IREDELL COUNTY HEALTH DEPARTMENT

IMPROVEMENT PERMIT / AUTHORIZATION TO CONSTRUCT / OPERATION PERMIT / EXISTING SYSTEM INSPECTION

PERMIT# 11726 PIN# 4715-82-9203 / 0187 9281 DATE 1-20-04

SUBDIVISION WARREN ESTATES BLOCK / SECTION _____ LOT 1 LOT AREA TOTAL 2.206 SITE CLASS. PS DESIGN FLOW 480 L.T.A.R. .25

INITIAL SITE SKETCH

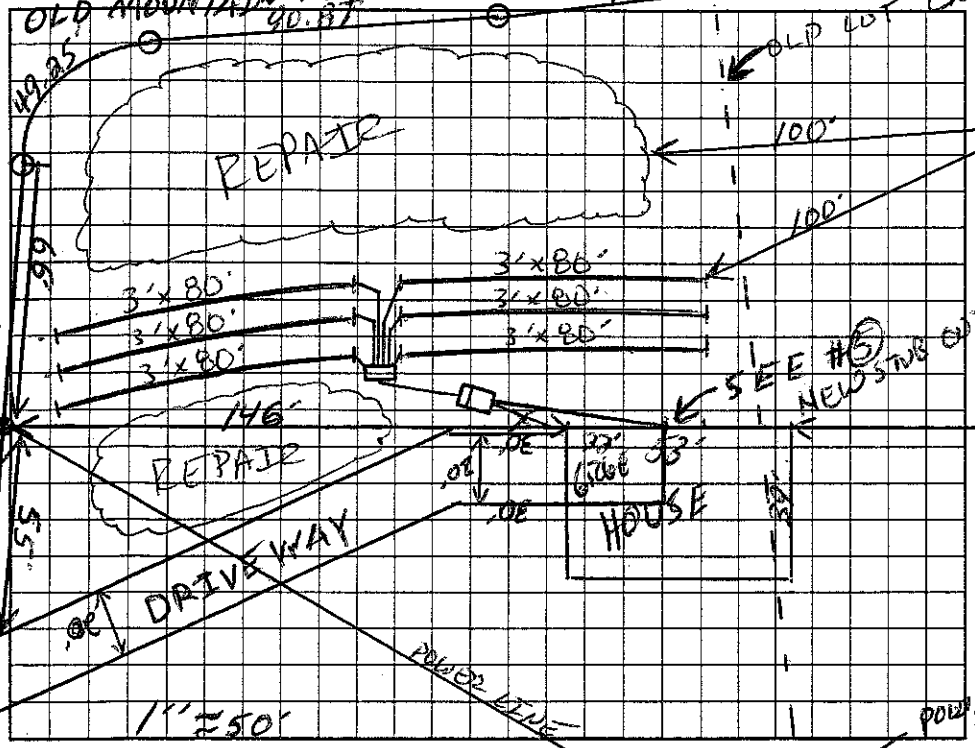
Comments:/Conditions: (1) STUB OUT 10" ABOVE NATURAL GRADE TO MAINTAIN GRAVITY FALL (2) DO NOT GRADE OUT HOUSE SITE FOR POSITIVE DRAINAGE REQMTS. KEEP CRAWL SPACE WALL OUT OF NATURAL GRADE ENOUGH TO

Comments:/Conditions: BACKFILL FOR POSITIVE DRAINAGE REQMTS. (3) SYSTEM IS DESIGNED ON A 2% SLOPE OR LESS. CONTOURS DO NOT HAVE TO BE FOLLOWED FOR DRAINLINE PLACEMENT (4) MAINTAIN SETBACKS. (5) SET DIST.

AS BUILT SKETCH BOX WITH SPEED LEVELERS SO ALL LINES WILL BACK UP TO THE BOX

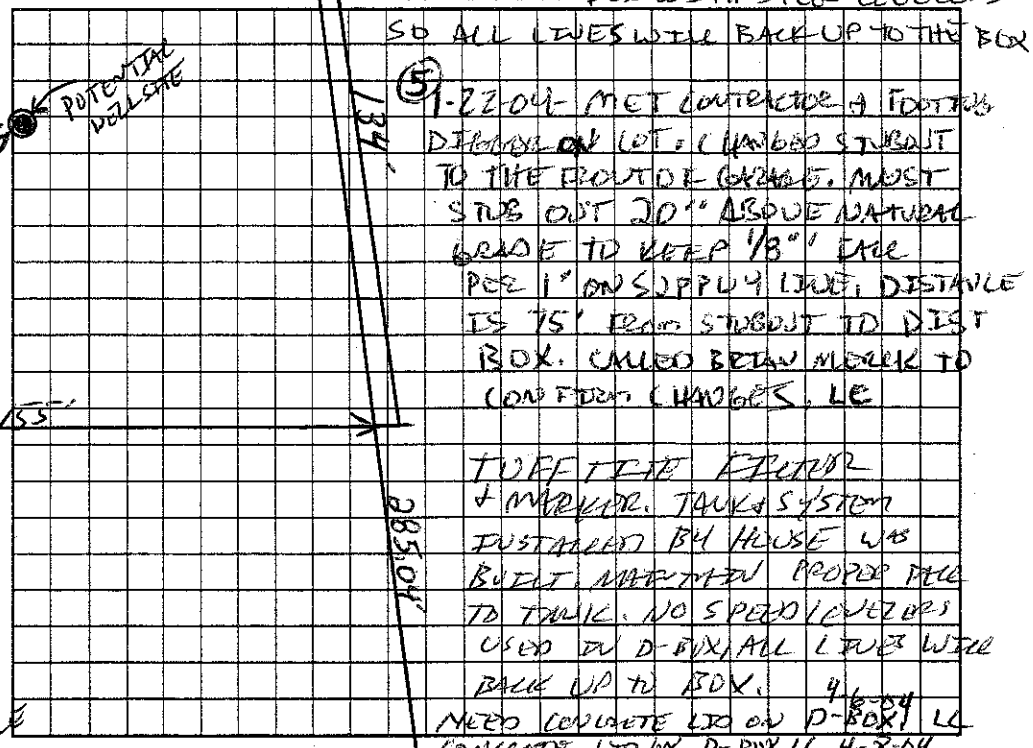
(5) 1-22-04 MET CONTRACTOR & TOPPED DITCH ON LOT. CHANGED STUBOUT TO THE FRONT OF CRAWL. MUST STUB OUT 20" ABOVE NATURAL GRADE TO KEEP 1/8" FALL PER 1" ON SLOPED LINE. DISTANCE IS 75' FROM STUBOUT TO DIST BOX. CALLED BRIAN MERRICK TO CONFIRM CHANGES. LC

TOPPED TO ENSURE 20" & MARKER. TANK & SYSTEM INSTALLED BY HOUSE WAS BUILT MAINTAIN PROPER FALL TO TANK. NO SPEED LEVELERS USED IN D-BOX, ALL LINES WILL BACK UP TO BOX. 4/6-04 NEED CONCRETE LID ON D-BOX! LC

"CONCRETE LID ON D-BOX" LC 4-8-04
